RE: Investigation of Integrated Resource Planning in North Carolina - 2010
Docket No. E-100, Sub 128

BEFORE THE NORTH CAROLINA UTILITIES COMMISSION
DOCKET NO. E-100, SUB 128

In the Matter of:)	INITIAL COMMENTS OF
Investigation of Integrated Resource)	SOUTHERN ALLIANCE FOR
Planning in North Carolina – 2010)	CLEAN ENERGY

Figure 1: Energy Efficiency Savings Impacts of Duke, PEC, and Leading Utility

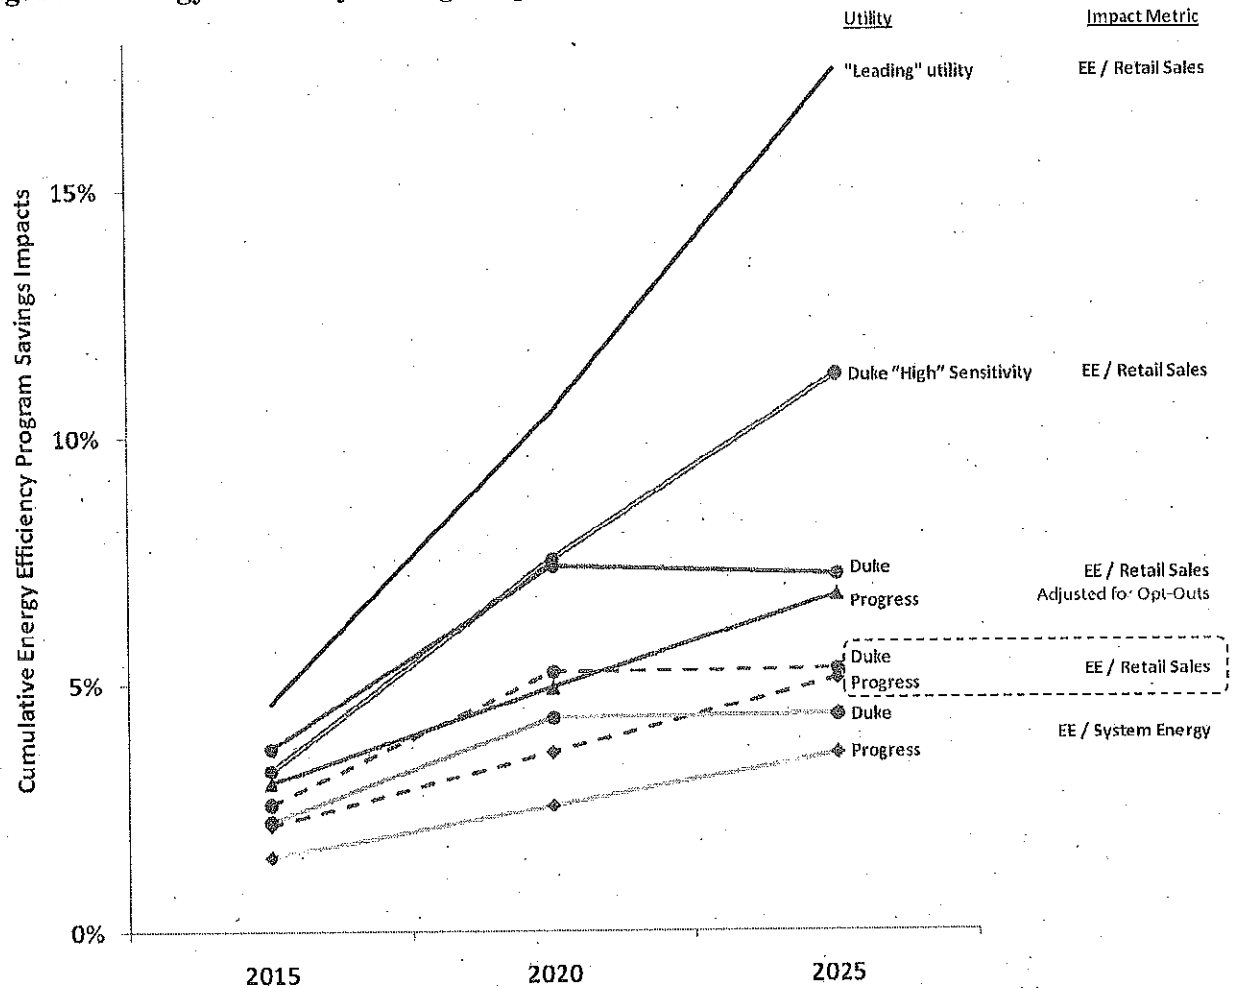
Figure 1 compares Duke's and PEC's projected energy efficiency savings to that of a generic "leading" utility.¹⁴ This "leading" utility represents a reasonable point of comparison because a large number of individual utilities operate programs whose annual energy savings exceed 1% of retail sales.¹⁵ Moreover, a 1% annual savings goal is consistent with the findings of recent studies, including a 2010 Georgia Tech meta-analysis of several potential studies in the South, which found that the achievable electric efficiency potential ranges from 7.2 to 13.6% after 10 years.¹⁶

Figure 1 illustrates that Duke and PEC lag significantly behind the typical leading utility, regardless of which baseline they use. Figure 1 also shows that Duke's energy efficiency program impacts grow during the first decade, but level off in the second decade of the planning horizon. PEC does project growth in program impacts in its second decade, but only enough to make up for deficient growth in the first decade. As a result, while aggressive levels of energy efficiency may be sufficient to eliminate a large amount of load growth through about 2020, the North Carolina resource plans are both skewed towards unnecessary supply-side additions in the second decade of the planning period.

Figure 2: PacifiCorp Preferred Resource Portfolio, 2008 IRP

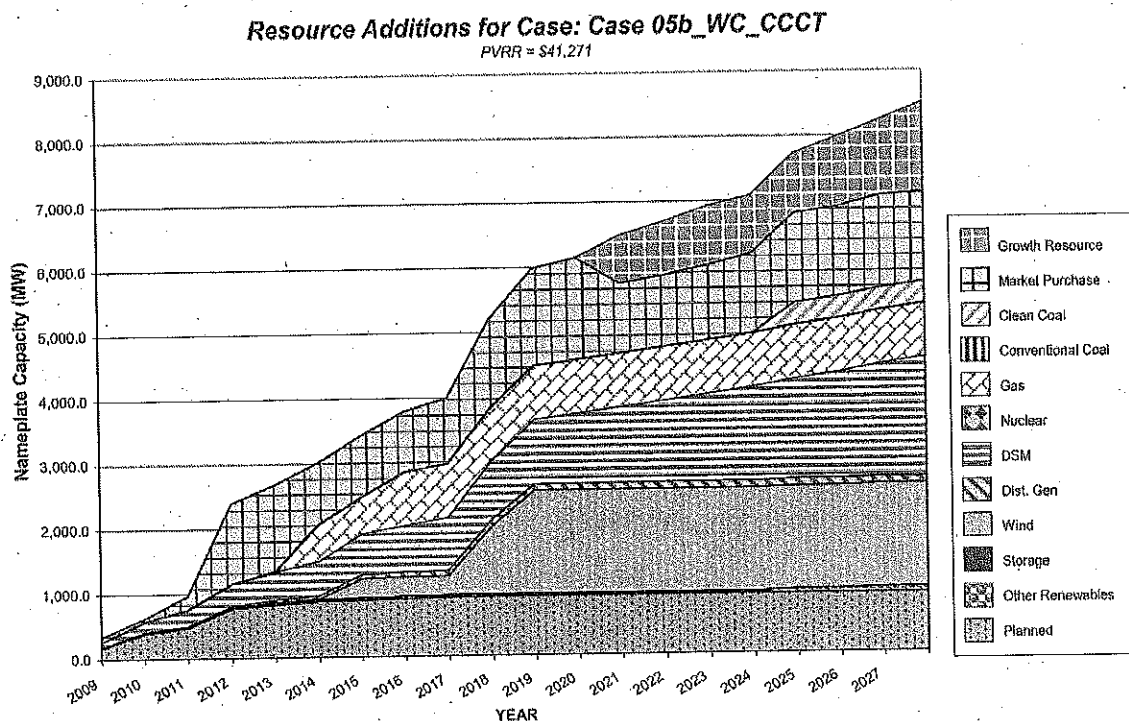
Further, PEC effectively assumes no further technological progress or development of new energy-saving practices. Duke is more confident about advances in efficiency, although this confidence is not fully reflected in its long-term resource plans.

SACE is unaware of any utility with a serious commitment to energy efficiency that assumes new energy efficiency opportunities will effectively cease to exist after a decade.²¹ For example, the Northwest Power and Conservation Council concluded in a retrospective review that at least 85% of the projected 20 year energy savings in its first regional plan were realized.²² Another example is illustrated in Figure 2, which shows the continued growth of the contribution of DSM resources to PacifiCorp's 2008 preferred resource portfolio. North Carolina utilities can and should rely on new technologies to provide additional cost-effective opportunities for efficiency in the outer years of the resource planning horizon.

Figure 3: REMI Model Estimates of Employment Impacts for Focus on Wisconsin Programs

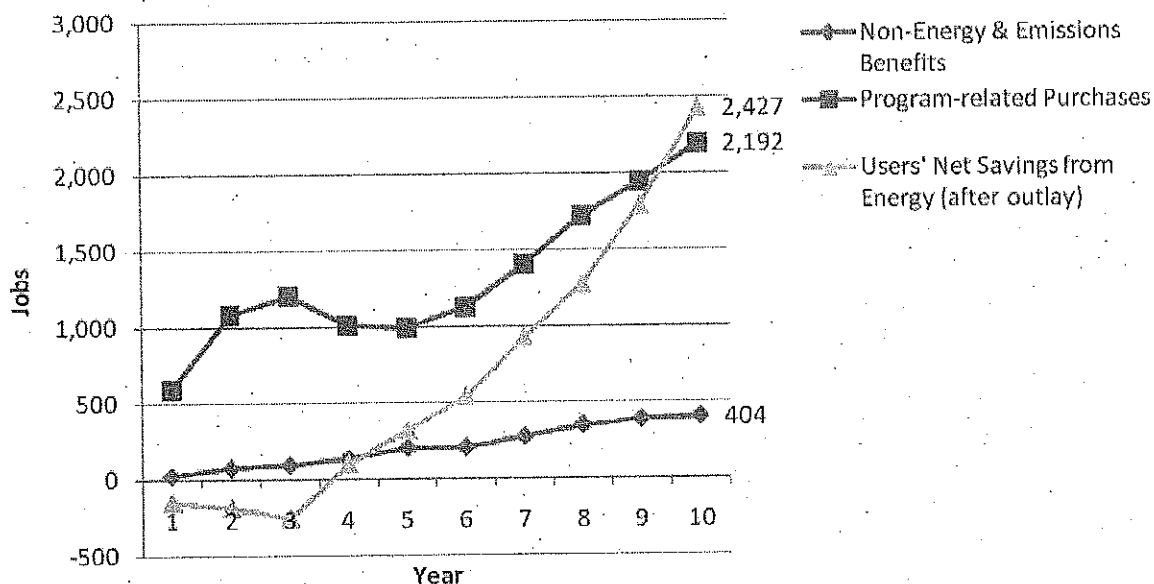
North Carolina utilities should consider using the REMI Policy Insight model, a highly regarded tool for conducting economic impacts analyses of resource planning portfolios. EPA has called the REMI Policy Insight model the “most sophisticated” approach for conducting economic analysis of energy policies or projects.³⁴

A 2010 study on Wisconsin’s energy efficiency and renewable energy programs provides a good example of how the REMI Policy Insight model can be used to cover “all aspects of changes in the economy,” including changes in business sales, gross regional product, real after-tax income, and jobs.³⁵ In that study, the REMI model showed various economic development impacts of efficiency and renewable energy programs, including lower energy costs, increased “business competitiveness,” and a lower cost of living, which in turn increased the attractiveness of the state as a place to live and work.³⁶ Figure 3 shows estimates of the impacts of energy efficiency and renewable energy programs on jobs.
